Cambodian Team

-DRIFT

-Observation

DRIFT (1)

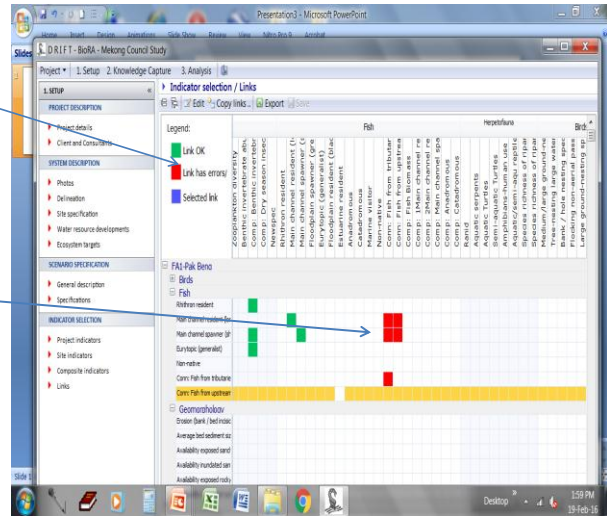
- The legend of link indicators should be changed from “error” to “delete or)”

- The color should be changed other color from red color .

DRIFT (2)

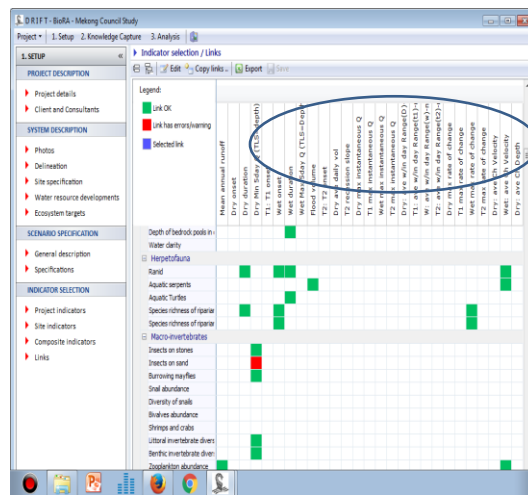
- It is not clear on the nutrient parameters in the link is either the nutrient Compound in the water nor sediment

DRIFT (3)

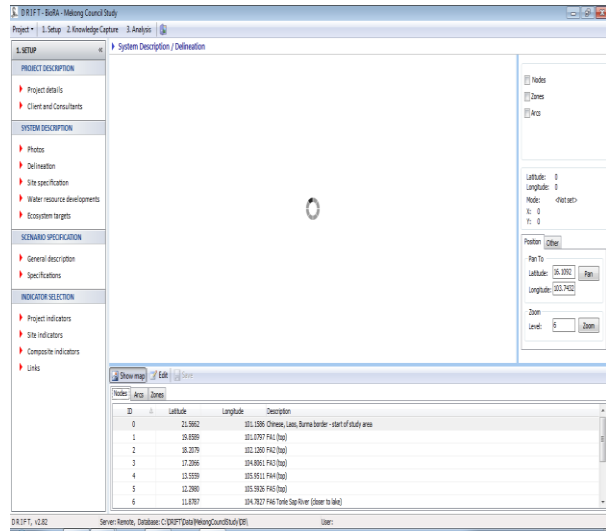
- The map should be set-up in the system
